ATTACHMENT I

ST. LUCIE UNIT I

Marked-up Technical Specification Page:

3/4 10-1

FIGURE
3.2.4.6-2

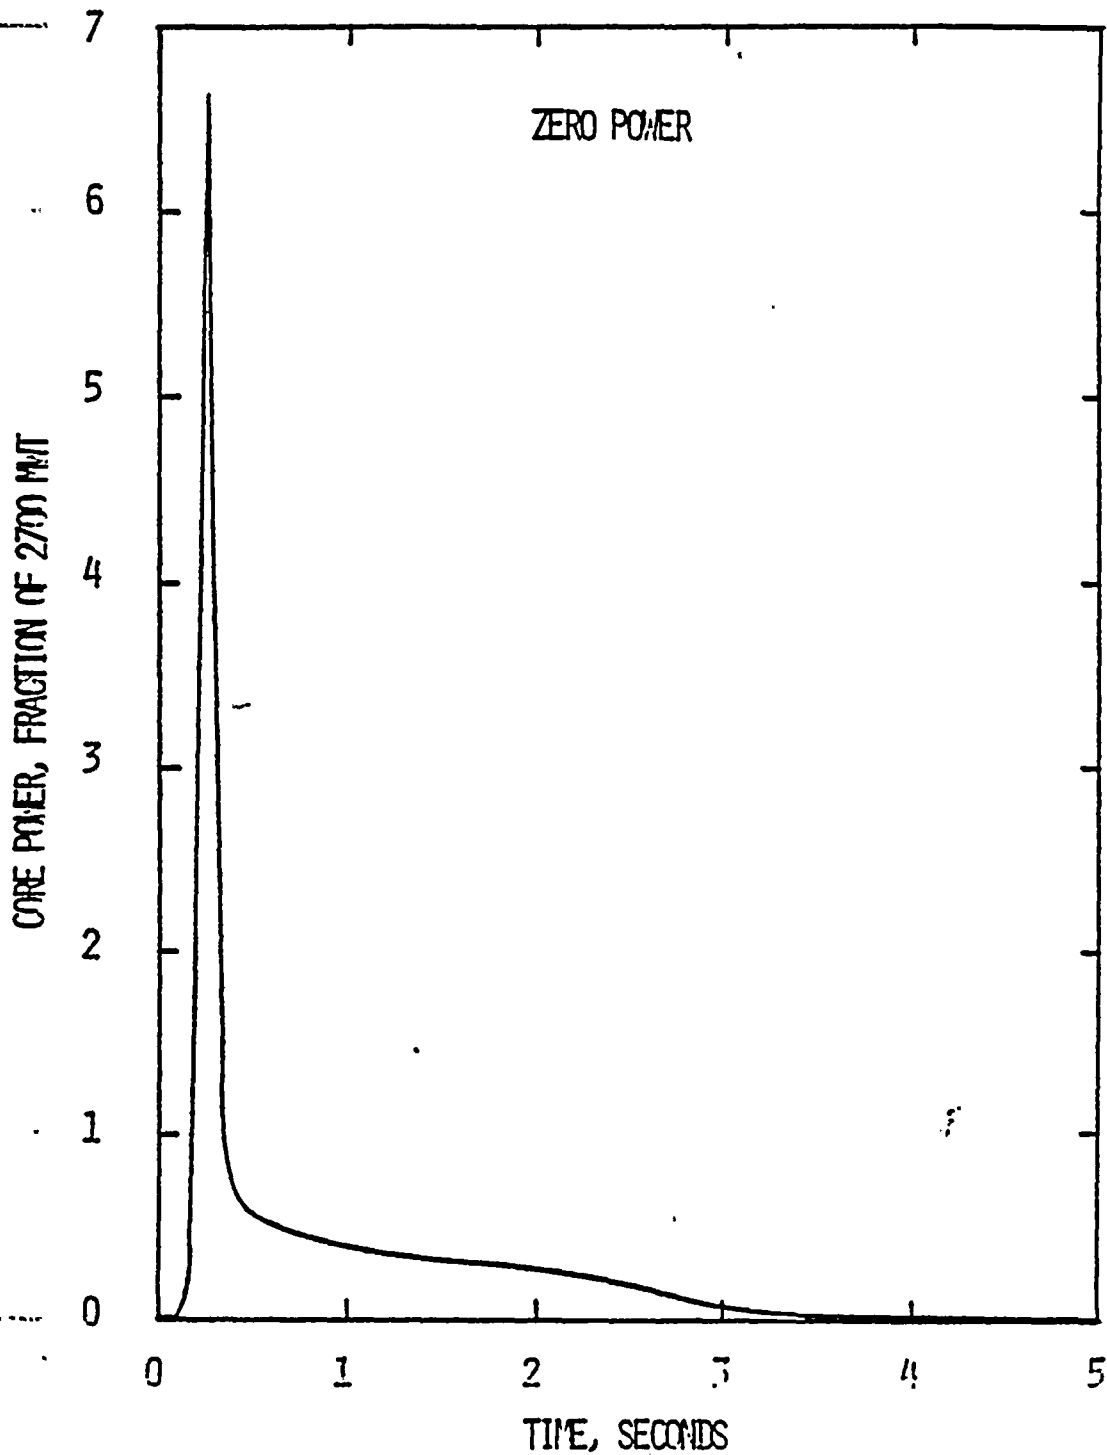
The CEA ejection event from Hot Zero Power (HZP) conditions results in a significant power increase for a brief period. The power increase is terminated by the negative reactivity produced by the Fuel Temperature Coefficient. Reactor shutdown is initiated by the high power level trip. As shown by the HZP CEA ejection power trace from the St. Lucie Unit 2 FSAR (Figure 1), the power level is minimal when the CEAs are predicted to begin insertion. A conservative calculation of the increased probability of a CEA ejection event from HZP with a stuck CEA has been performed. It has been determined that the change in probability of a CEA ejection with a stuck CEA is 1.0×10^{-9} when the requirement for trip testing is extended from 24 hours to seven days. This increase represents a negligible increase in the risk to the public when compared to the safety goal proposed by the NRC in NUREG-0880. Therefore, it is concluded that the results and consequences of this type of event have not significantly changed due to the proposed Technical Specification change.
